Subject: Applicant: Kohler Company
FCC ID: N82PNA1
Confirmation Number: EA93436
Correspondence Ref. No. 19988

Reference: Kohler Waiver Request submitted June 16, 2000.

Attachments: JPEG Photo of sample PCBA, Rev 08.

Photo of VTK Unit S/N 08.02 Sensor PCBA, mounted on fan.

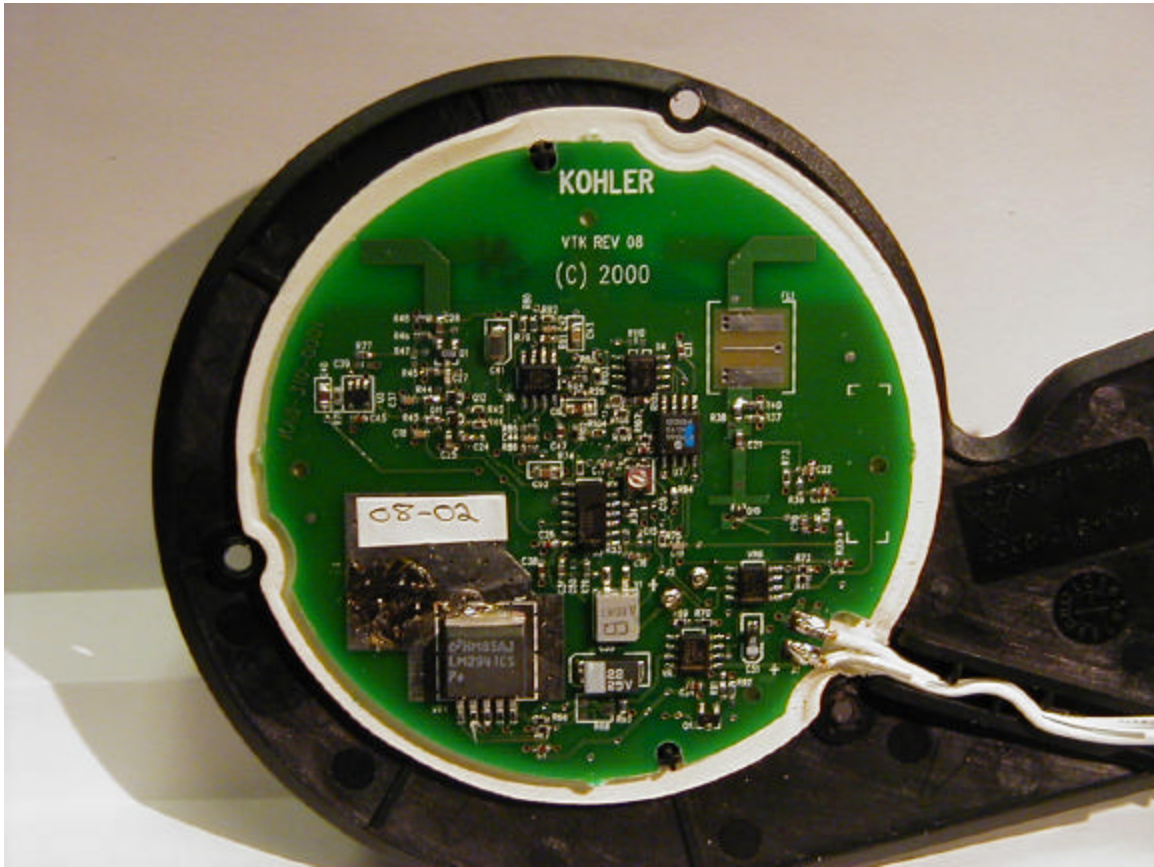
1. The unit tested for the amended certification report is Rev 08 of the design, and incorporates the transmit filter. The data attached to the test report submitted on July 10, 2001 contains some data pages from the test report submitted with the original application (where the data have not changed) and revised data pages (where data have changed as a result of the added filter). Submitted separately today, with a request for confidential treatment, are a current Block Diagram, Schematic and Theory of Operation for the tested product. Also attached to this letter is a photo of the PCBA as mounted in the enclosure. We did not obtain additional photos of the fan and power supply, because these have not changed and we wanted to preserve the unit for testing by the Commission. I believe other than the color of the case, the external photos contained in the test report are similar between the February 2, 1999 and June 28, 2001 tests. The unit does not
